STAFF REPORT

Administrative Amendments – 2025 Municipal Planning Strategy and Land Use By-law.

DRAFT 2026/04/16

1-1

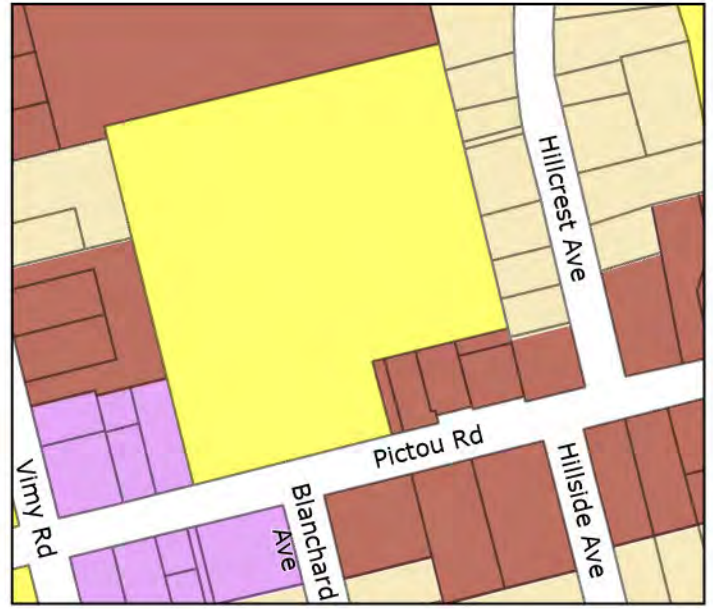
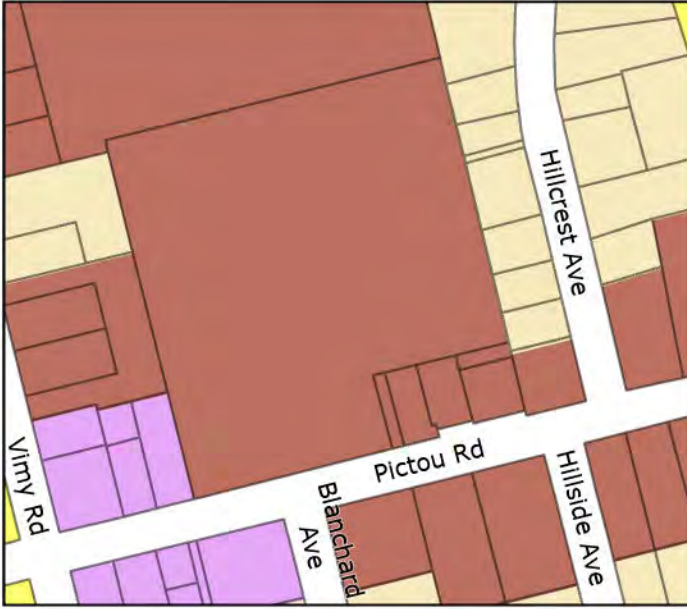
Issue	Recommended Amendment
1. FLUM for Bible Hill/Valley	1-1 Bible Hill Elementary School on Pictou Rd, (PID 20068441) & 1 -2 Shannex (Vimy Court) on Vimy Rd (PID 20233029) need to change to Institutional from residential. 1-3 The Northumberland Lamb Marketing Co-Op (PID 20249892) needs to change to RLD (Low Density Residential) from CDD. It has historically been considered an existing non-conforming

1-4

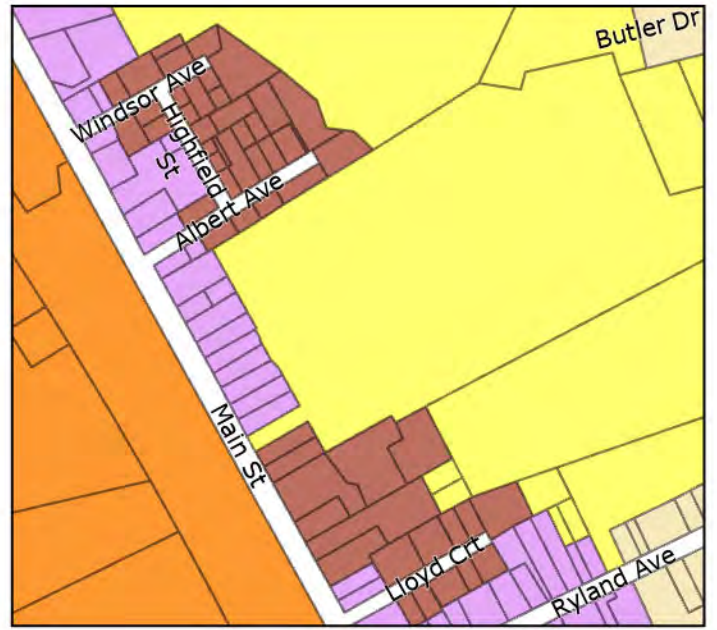
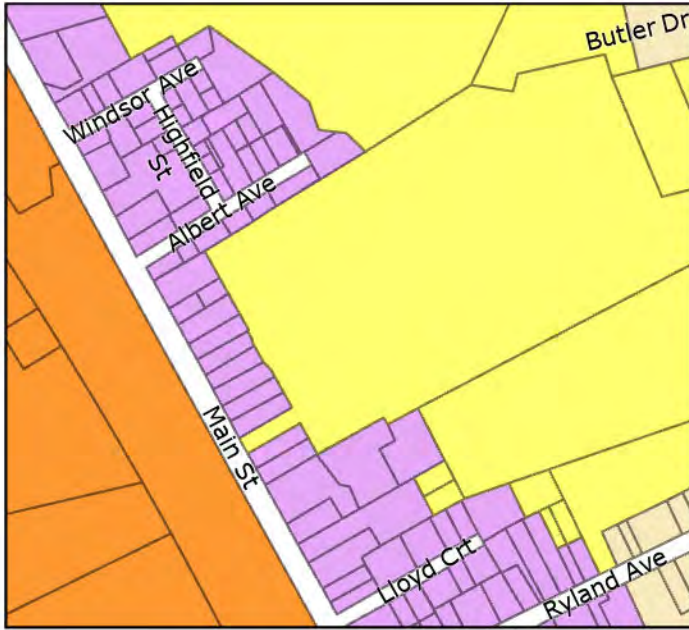
Issue	Recommended Amendment
	<p>use at that location since the 1980's, which is why it has always been considered residential in previous plans & by-laws.</p> <p>Two areas to change to Residential Medium High Density from Commercial: 1-4 sections along & off Main St from Lloyd Court to Windsor Ave, excluding any existing businesses.</p> <p>1-5 sections along Pictou Rd: between Oak Drive & Village Court. 1-6 Lands on the west side of Pictou Road in East Mountain to go from C Commercial to RMHD Medium High Density Residential, reflecting what has been the development trend in recent years. From PID 20266276 to 20010922.</p>
<p>2. FLUM for Brookfield</p>	<p>2-1 The Firehall (PID 20036893), 2-2 the Sportsplex (PID 20167375), 2-3 the Elk Park Ballfield (PID 20167375), 2-4 the schools (PIDs 20161105, 20408951 & 20411575) should all be Institutional not residential.</p> <p>2-5 The wetlands trail (PIDs 20471785 & 20307377), & 2-6 golf course (PIDs 20325494, 20004008, 20004032, 20036331, & 20001384) should be Parks & Open Space, not Rural.</p>

3-1

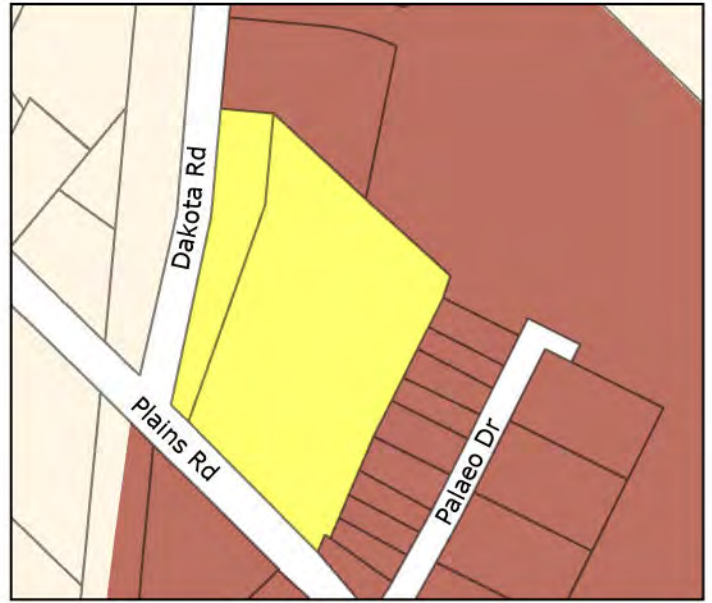
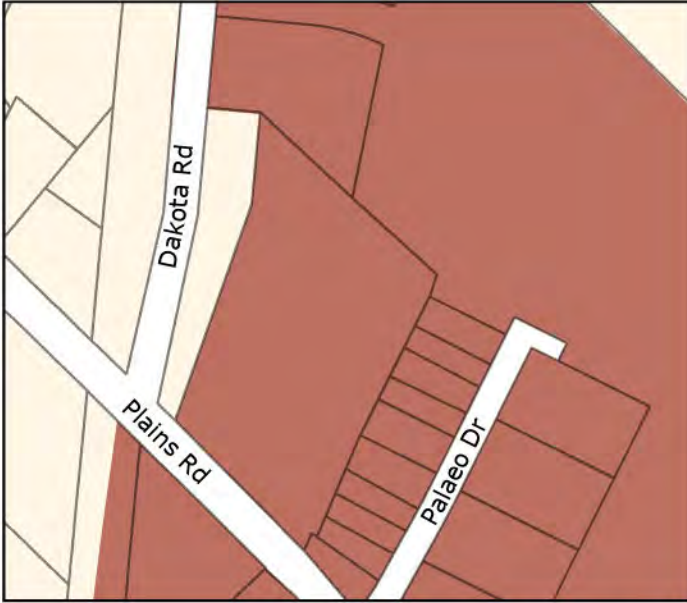
<p>3. FLUM for Debert</p>	<p>3-1 Shannex (Debert Court) PID 20451696 & 20452041 should be Institutional. 3-2 The six new homes on Dieppe Avenue should be residential (RMHD), not Parks & Open Space. PIDs: 20503595, 20503587, 20503579, 20503561, 20503553 & 20503546.</p>
<p>4. FLUM for North River</p>	<p>4-1 The North River Elementary School (PID 20007134) should be Institutional not Rural.</p> <p>4-2 The Glendale Drive subdivision as well as Wile Crest Ave., Dundee Avenue & Mountain View Drive subdivision should be RLD (Low Density Residential) not Rural. These areas have access to central sewer.</p> <p>4-3 Lands recently acquired by the Municipality on Dickson Drive to become Institutional from RLD (Residential Low Density). The 4 PIDs are: 20375473, 20375507, 20439683 and 20246443.</p>
<p>5. FLUM for Onslow</p>	<p>5-1 Parkland on Summer Hill Place to be Parks & Open Space, not RDL. The PIDs are 20501821 & 20501839.</p> <p>5-2 Parklands on Sunrise Court to be POS - Parks & Open Space not RLD. PIDs: 20501821 & 20479994.</p>

6-1

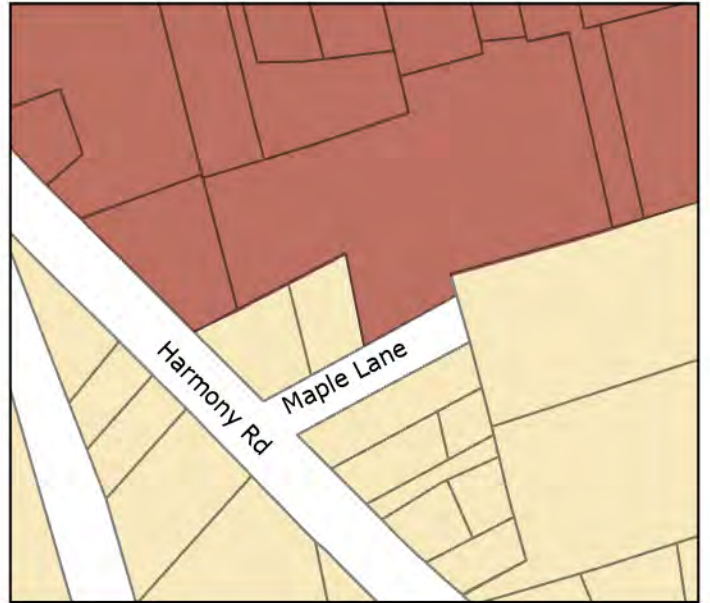
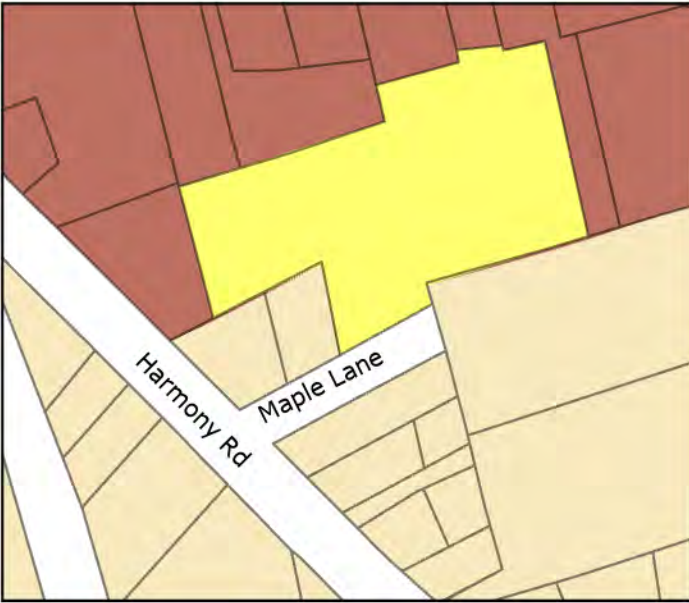
<p>6. FLUM for Salmon River</p>	<p>Two properties are incorrectly designated as Institutional. Both should be RMHD (Medium-High Density Residential): 6-1 PID 20039376 – multiple units on Maple Lane. 6-2 PIDs 20506523 & 20037073 – the former Salmon River School site.</p>
<p>7. FLUM for Tatamagouche</p>	<p>None of the existing Institutional uses are shown so change the following from RMHD to Institutional: 7-1 Hospital PIDs: 20087938 & 20299871. 7-2 Library PID: 20457123 & Monument PID 20158457. 7-3 School PID: 20087920. 7-4 North Shore Rec Centre PIDs: 20087854, 20246427, 20246435 & 20088134. 7-5 Waste Water plant PID 20085841. 7-6 Tatamagouche Cemetery PID 20508420. 7-7 Tatamagouche Firehall PID 20086757.</p>

9-1

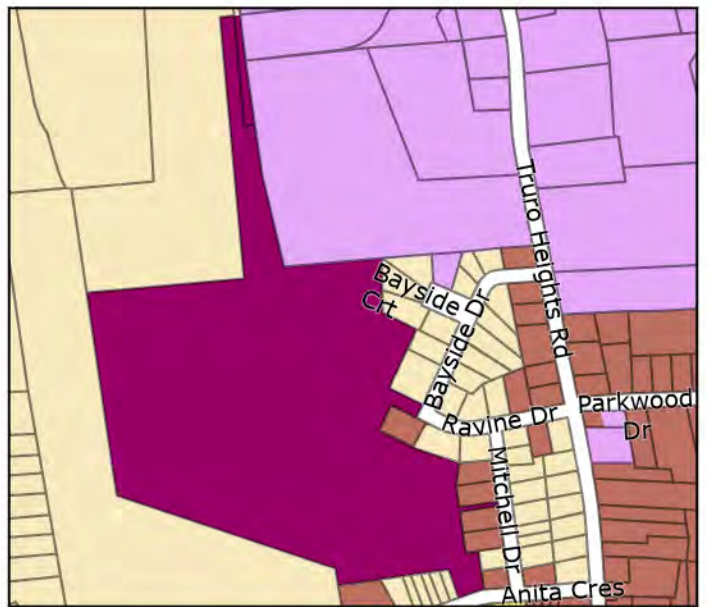
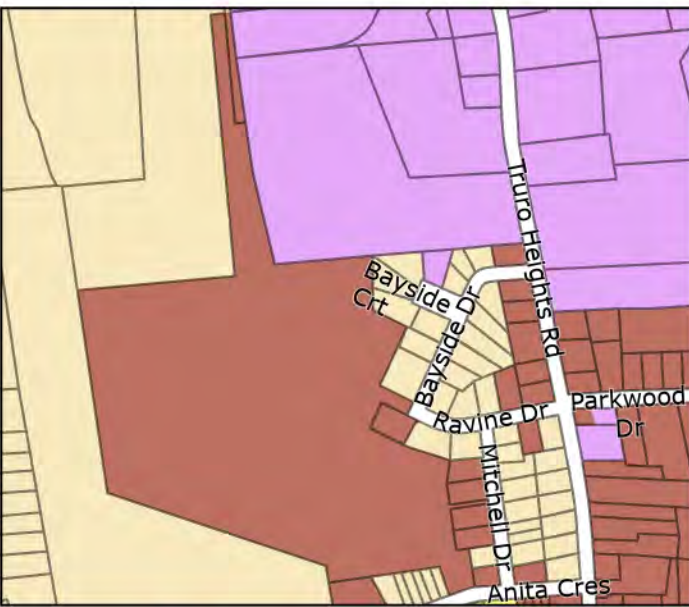
8. The overall Future Land Use Map on page 98 – Sunrise Shore Marina	8-1 The Sunrise Shore Marina to be Parks & Open Space not Rural. PID is 20267423.
9. FLUM for Truro Heights	<p>9-1 The waste water plant to be Institutional not AP. PIDs 20218137, 20314175 & 20213948.</p> <p>There are several errors on this map as it appears as though some zoning layers were used instead of FLUM designations. 9-2 PID 20409249 (former golf course) – to be CDD not RMHD. 9-3 PID 20284725 – existing commercial to stay as Commercial, not residential. 9-4 20216727 – partial commercial designation correct – just needs to be adjusted slightly and PID 20216719 to be RMHD, not commercial. 9-5 PID 20269379 - entire lot to be RLD. A portion of it is incorrectly designated as RMHD.</p>
